Technical Preservation Services
Preservation Assistance Division
National Park Service
U.S. Department of the Interior
Washington, D.C.

Interpreting the Secretary of the Interior's Standards for Rehabilitation

Volume II

3. Initial canopy design was not approved by NPS because its height obscured the first floor windows.

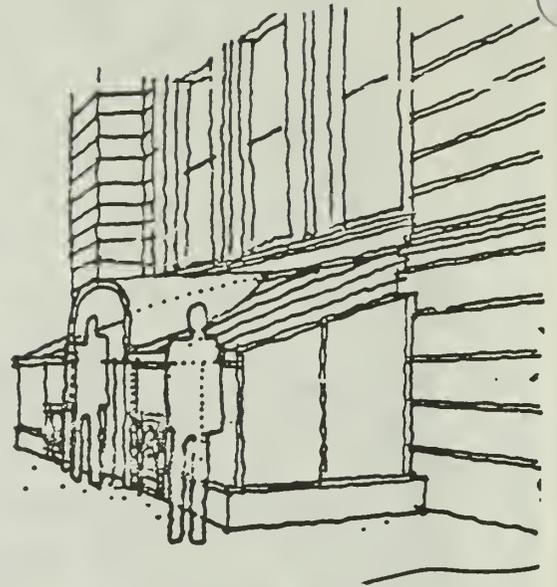
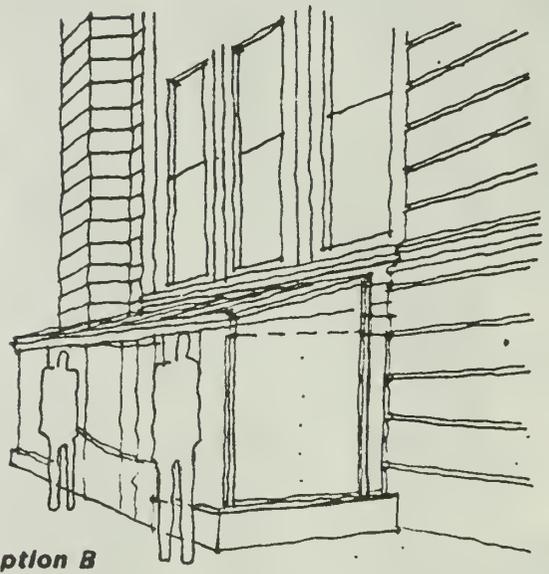
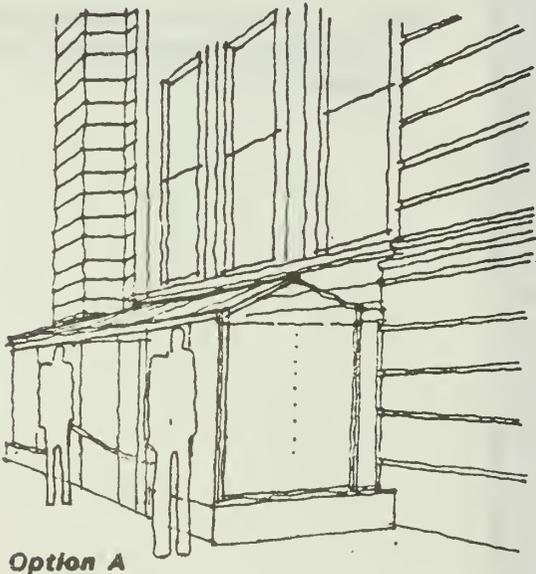
The architect's initial design for the glass and dark colored anodized aluminum canopies incorporated a standard vault with a flat roof section which NPS felt was a visual intrusion upon the substantially unaltered facade. Although there would be no destruction of historic material, the curved roof line of the proposed canopy extended well above the level of the earlier vestibule and obscured the lower portion of the first floor windows, a distinguishing feature of the building (see illus. 3). For the overall project to meet the Standards, NPS informed the owner that any new canopy would have to be located below the sill of the first floor windows. In response, the architect prepared one alternative design for the canopies which met the height condition, but which--both NPS and the owner agreed--introduced several other design problems (see illus. 4) which might affect pedestrian safety.

At a later date, citing these problems and increased construction costs, the owner again sought approval of the initial design. NPS continued to maintain its earlier position that the initial design did not meet the Standards but felt that alternative canopy design options still existed that would meet the Standards yet at the same time be practical and esthetically pleasing. At this point, the owner elected to appeal the denial, seeking approval of the overall project including the initial canopy design. Prior to the hearing, however, the architect submitted two new scaled-down alternatives for the glass canopies, both of which were approved by NPS (see illus. 5), thus enabling the entire project to be certified. Following project approval, the Option "A" canopy was actually constructed (see illus. 6).

5. Final canopy designs (Option A and B), both of which NPS approved. The Option A design was ultimately constructed.

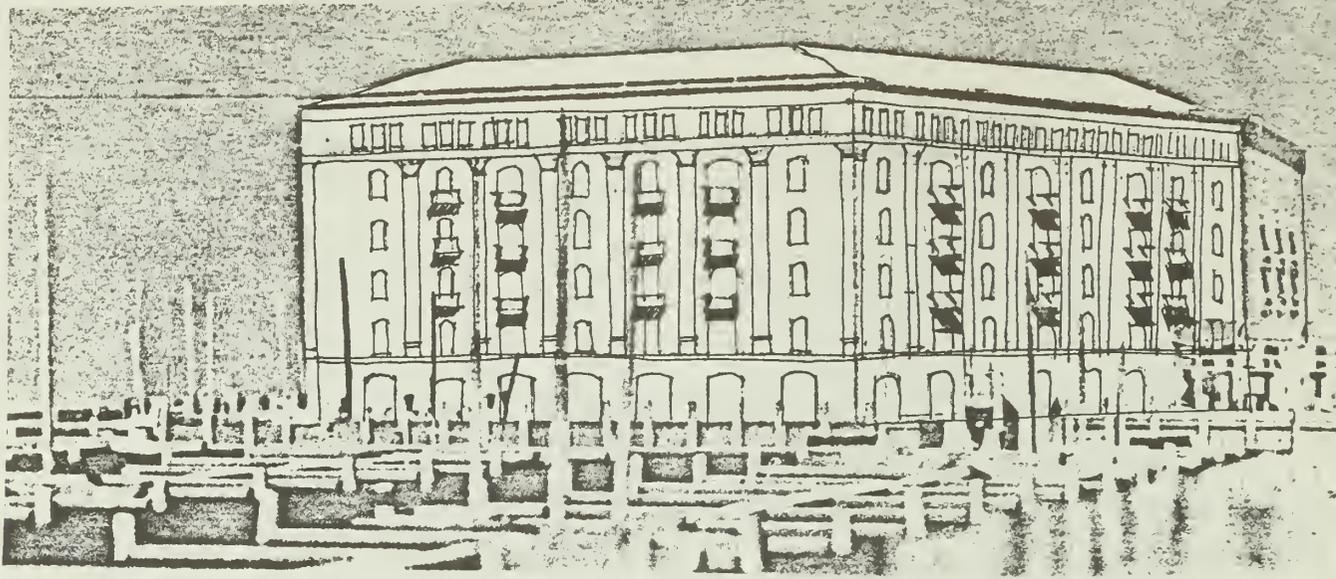
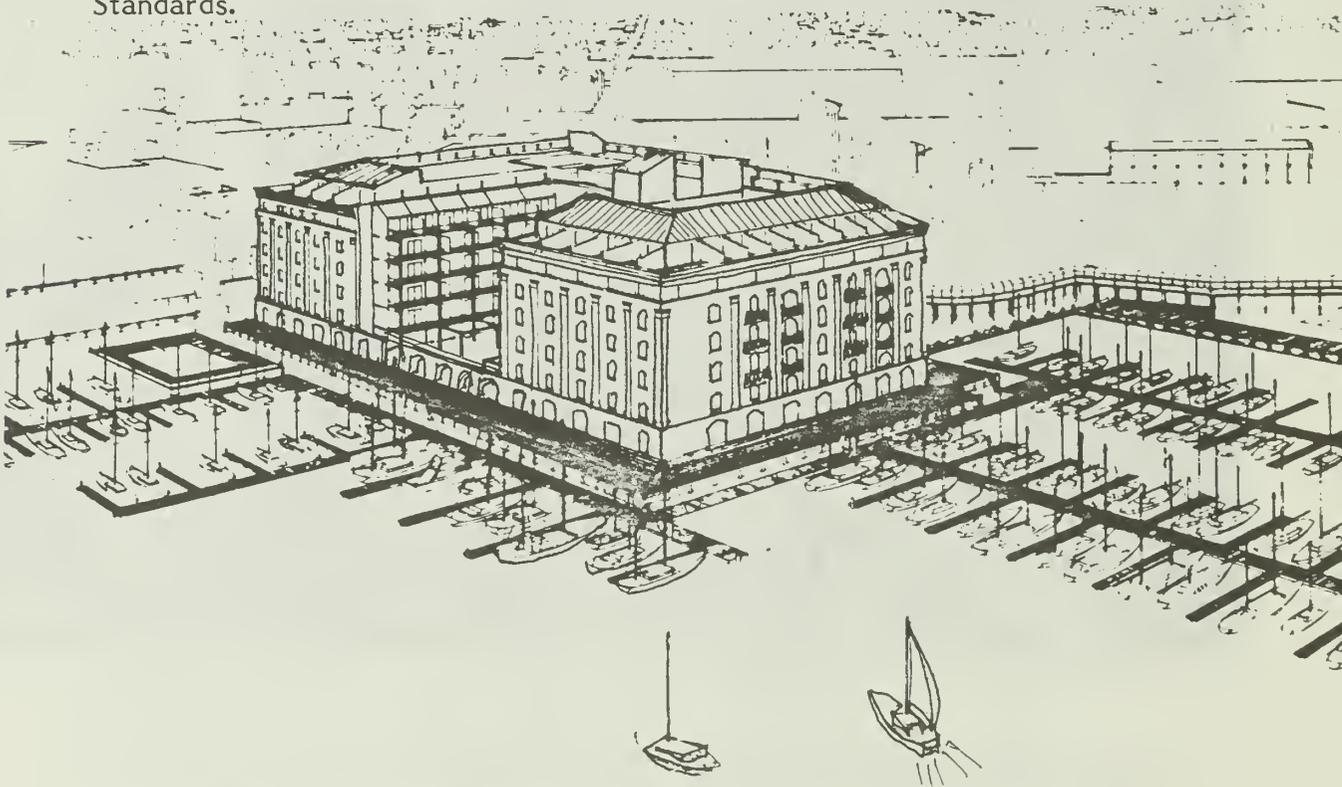
In reviewing the proposed changes, the appeals hearing officer determined that the architectural elements that contributed to the historic character of the building should be clearly outlined: e.g. the massiveness of the 200' x 400' structure; the highly articulated facades composed of alternating bands of windows openings and pilasters; and the vertical effect of these bands with a hierarchy of openings from the ground floor to the top floor complemented by the horizontal beltcourses, top floor frieze and corbelled cornice. The brickwork was well executed and even with the substantial detail on the surface of the building, the facade retained a strong sense of flatness as there were no deep surface penetrations (see illus. 1). In summary, the architecture of the warehouse was very sophisticated for this type of construction and was significant both to the building and to the 19th-century district in which it was located.

Following an onsite inspection of the warehouse and the district, the hearing officer sustained the denial of the regional office for a number of reasons. He felt that the planar quality of the exterior walls would be drastically altered by the addition of projecting balconies with their inherent shadow lines (see illus. 2). He felt that widening selected bands of windows would interrupt the regular rhythm of the window bays. Widening the upper floor windows would also alter the hierarchy of window openings from large openings on the first floor to the small openings on the top floor. His last major concern was the proposed cut in the building, which not only removed the significant original materials of the facade, but altered the massive quality of the warehouse structure (see illus. 3).

While sustaining the decision of the regional office, the hearing officer encouraged the owner to reconsider the proposed changes to the building and resubmit his application with a proposal that would meet the Standards. While the hearing officer felt that the building could not accommodate any external projecting balconies, he felt that an atrium court that did not remove any of the

facade and a modified scheme for widening the windows that reflected the hierarchy of existing openings could be considered.

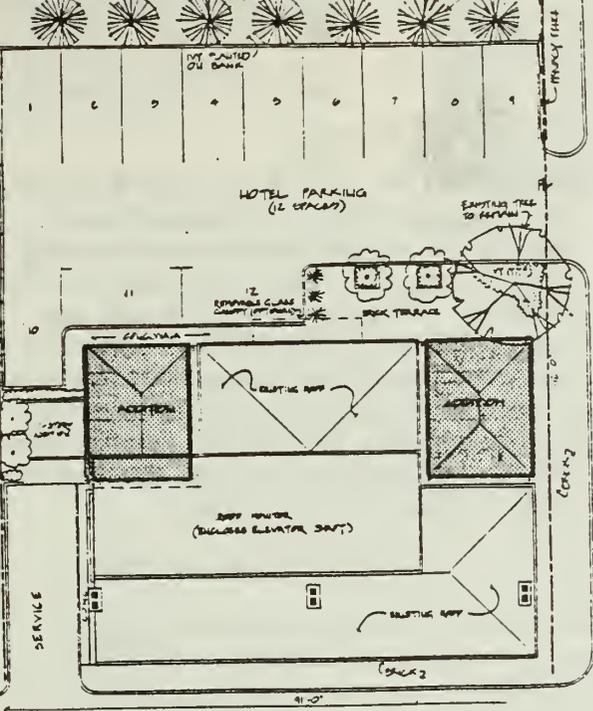
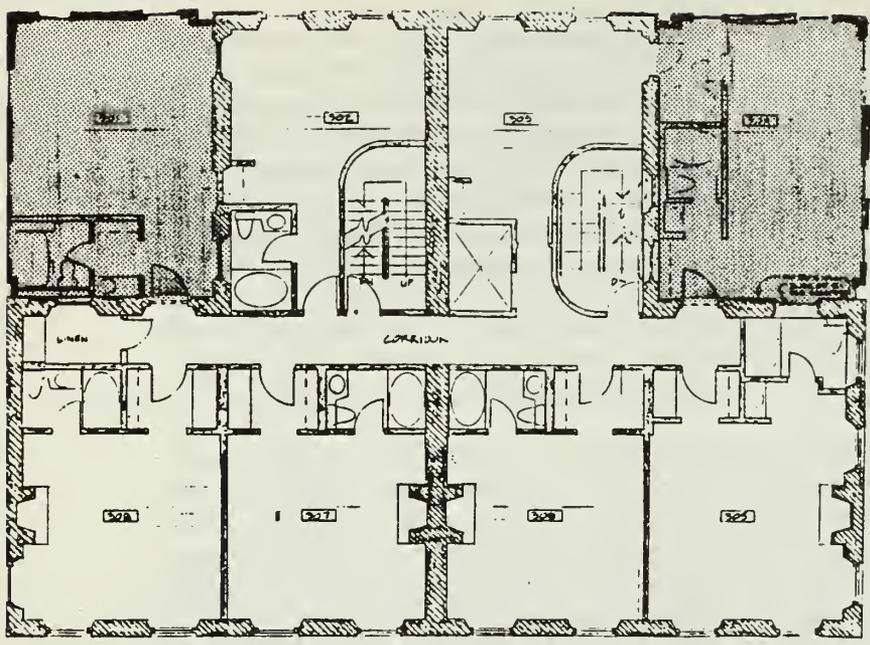
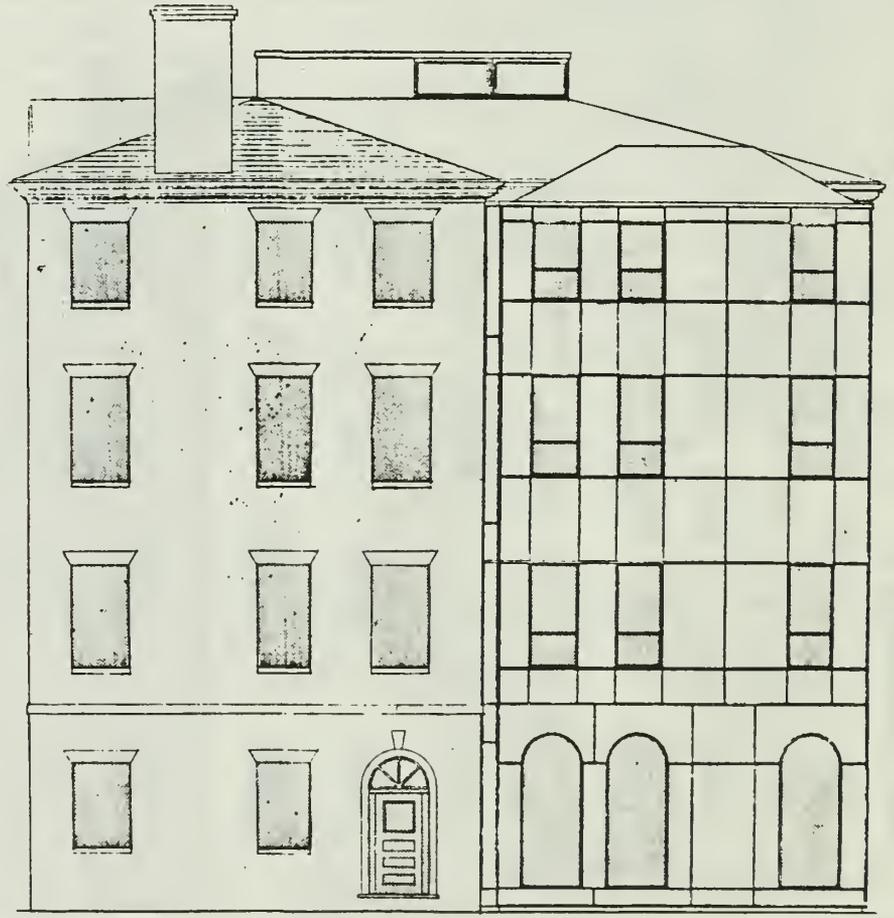
In reviewing the initial application, the State office made note of several important aspects of the project that would require redesign. As a Federal era design, the pair of town houses was distinguished by narrow, one room deep "T" shaped plans. The state felt that the infilling of this plan should not give the appearance of earlier mid-Georgian plans that were heavier in mass and proportion. As such, the State recommended that the new additions read as separate structures connected to the historic resource, thereby preserving the original sense of the Federal plan. In addition, the new construction should be attached to the historic building with a minimum of damage to historic fabric so that if, in the future, the additions were to be removed, the basic form and integrity of the historic structure would remain.

The SHPO suggested that a contemporary design for the additions be considered, that the materials used provide a neutral backdrop for the historic resource, that the roofline of the additions be lowered so as not to damage the ornamental historic cornice, and that care be taken to minimize removal of historic fabric. In essence, the new rear additions should be treated as separate pavilions that would read as new construction in order to preserve the character-defining features of the historic resource. The owner was amenable to these suggestions and resubmitted his design (see illus. 2), which was then forwarded to the regional office with a recommendation for approval.

In reviewing the proposal, the regional office agreed with the State on the need to clearly differentiate the new construction from the historic resource through the use of materials and setback connection details, while achieving compatibility in terms of scale, proportion, and location. A modern flush metal panel system was selected for the exterior sheathing of the new construction to act as a neutral backdrop to the carefully restored historic brickwork. The use of glazed panels recessed between the historic masonry and the new addition would allow the distinct feature of the Federal plan to be exposed. In addition, much of the original rear walls of the historic structure would remain exposed with the windows in place as part of the new construction. This would reduce the loss of historic fabric while leaving clear evidence of the connection between the original and new construction (see illus. 3).

Illustration #2. PERSPECTIVE VIEW. The revised design treated the rear addition as a modern pavilion to clearly differentiate it from the historic structure.

3. A floor plan with side entrance and stair hall, and front parlor containing diagonally arranged partitions, chimney and mantel were identified as important in defining the historic character.

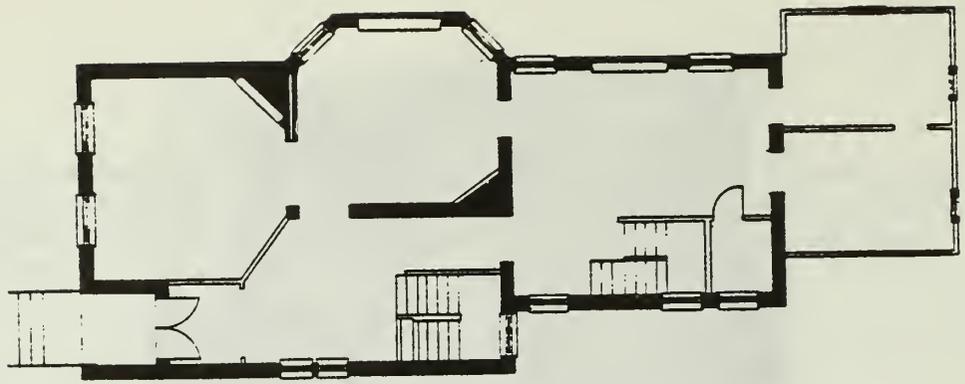
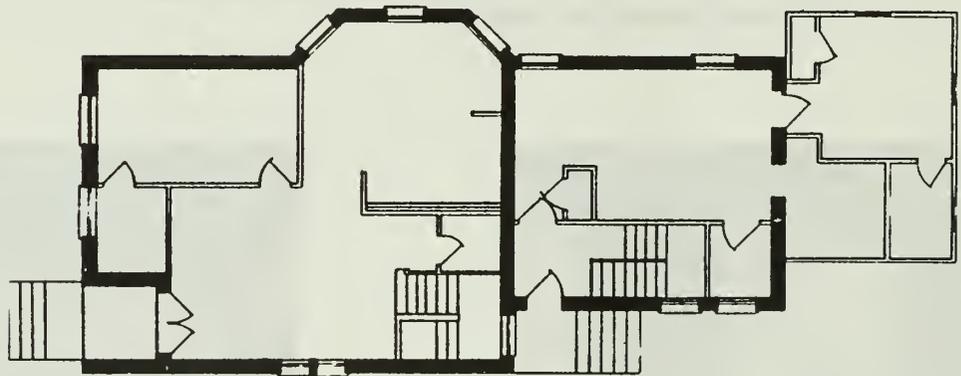
Interior demolition had already begun when the project was reviewed by the National Park Service. This work included removal of historic material and features which the owner assessed as "unusable." The owner's proposed floor plan for the apartments (see illus. 4) required removal of existing partitions; subdivision of the front parlor in order to maximize rentable bedroom space; and relocation of the living area to the former historic entrance and stair hall space. Substantial rearrangement of rooms throughout the building resulted in removal of additional partitions and corner fireplaces. Door and window trim, as well as baseboards and doors, were also removed. The regional office of the National Park Service felt that the interior materials, features, and spaces were important in defining the historic character, and should have been retained and repaired to the greatest extent possible. In consequence, the project was found to be in violation of Standards 2, 5, and 6 and was denied certification for tax benefits.

4. Scheme "A" was proposed by the developer to make the project meet the Standards. This change in the design would simply have provided expansion joints to show the difference between the historic building and the new additions. The proposal was rejected.

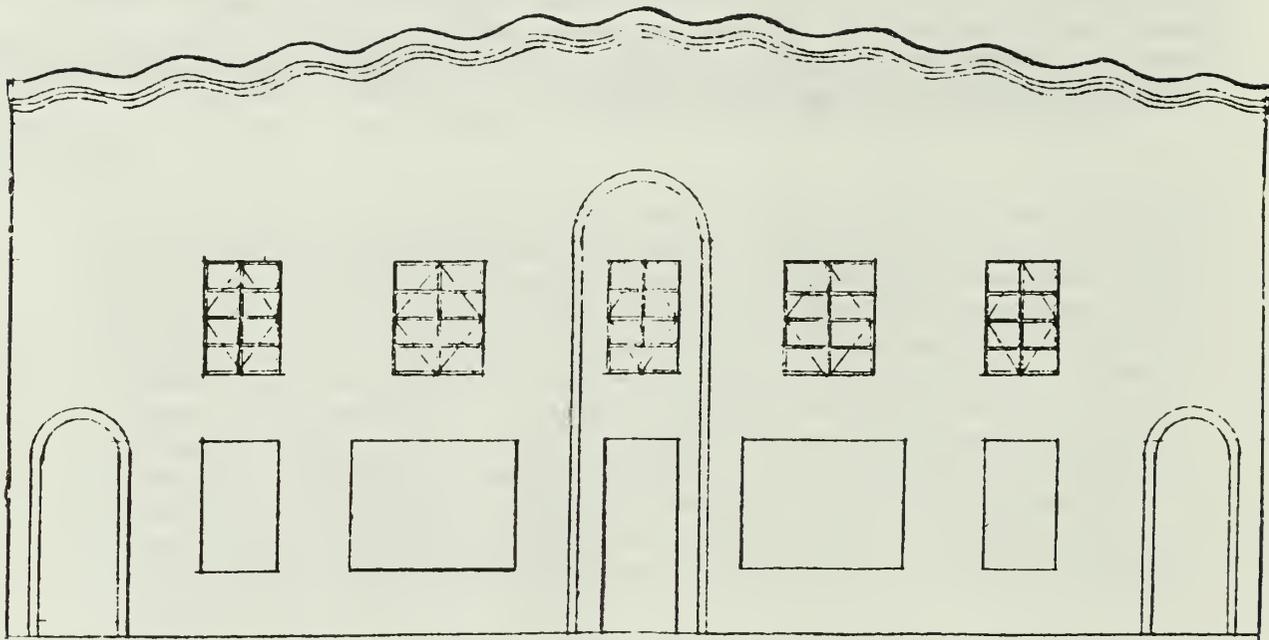
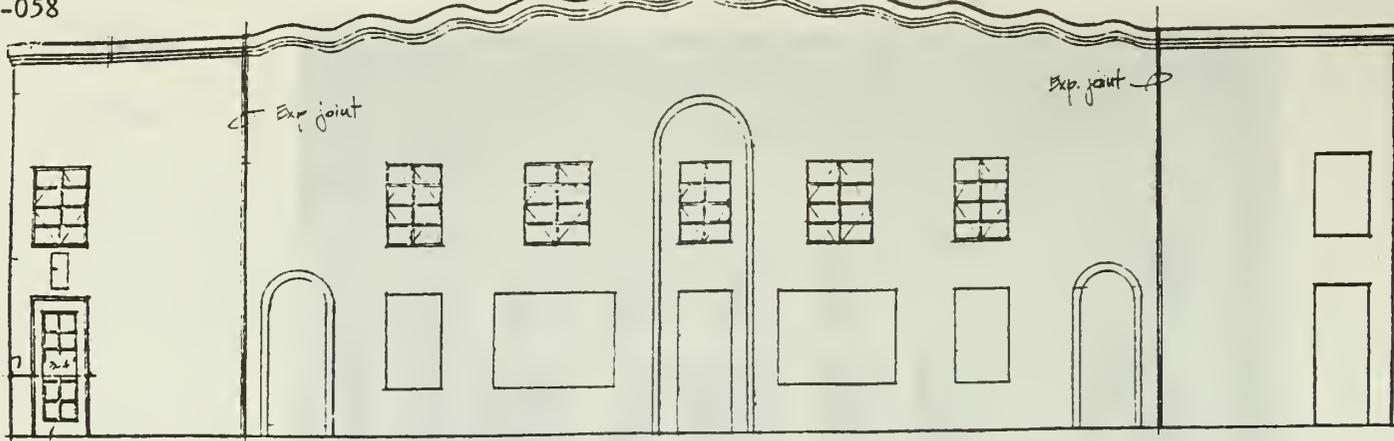
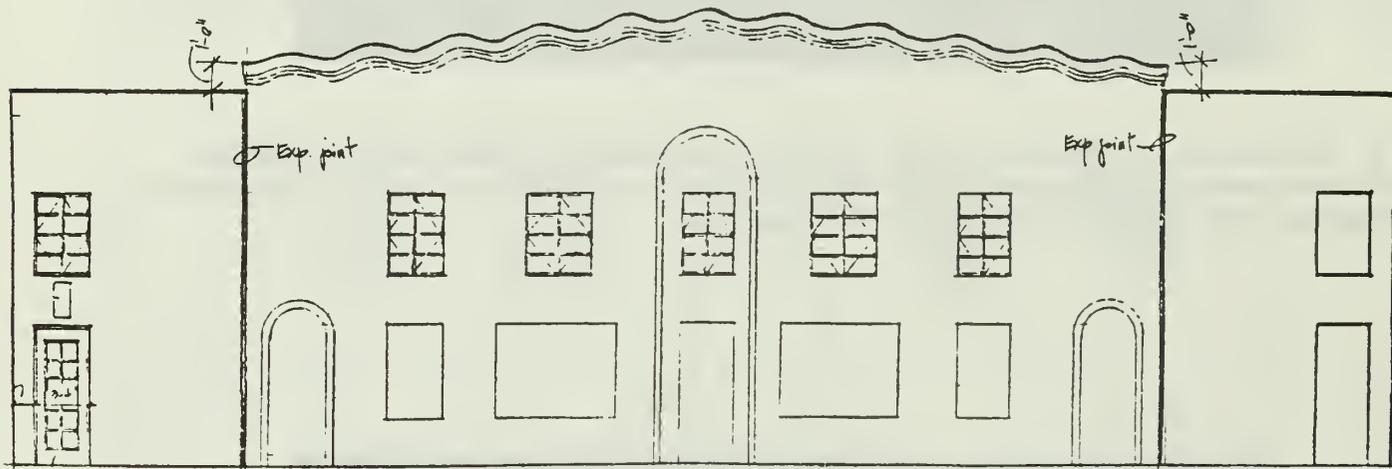
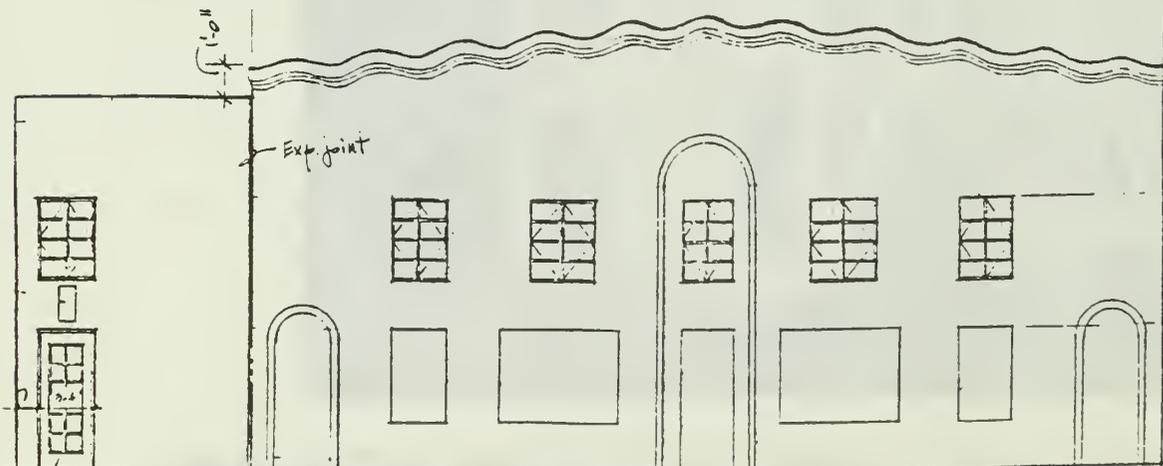
The new additions, consisting of the exterior stairs enclosure at one end of the facade and the wing wall at the other end, increase the length of the facade by at least one-third, thereby altering significantly its overall mass, scale, and proportional relationships. Further, these additions extend and expand on the symmetrical historic design of the facade in a way that lends to it a degree of expansiveness...not present in the simple design character of the structure's original design features. It is apparent that the attempt to match the color, texture, and detail of the original design and to continue its symmetry by extending the facade wall was motivated by a desire to preserve the historic character of the building. In effect, however, this matching new design is incompatible: it compounds the additions' negative visual impacts on the original design by making contemporary and historic portions of the building indistinguishable from one another.

When the project was subsequently appealed, the Chief Appeals Officer sustained the regional office's decision that the new additions violated Standards 5 and 9, adding that "they also give the building a monumentality that, historically, it never possessed, thus changing its historic character." In consequence, the project also failed to conform to Standard 2. As part of the appeals process, the architect forwarded three drawings (schemes A, B, and C; see illus. 4, 5, and 6) for possible changes to the new additions to bring the project into conformance with the Standards and thus qualify for Federal historic preservation tax incentives. After reviewing all of the drawings, the Chief Appeals Officer concluded in his final letter to the owner:

and new construction clear; and would restore to the building its aspect of a modest, simplified Spanish Colonial Revival commercial structure. Demolition of the wing wall would allow one to view the continuous wavy cornice as it carries around the corner. If the final revised project fails to meet any of the above conditions, it will not meet the Standards and cannot be certified.
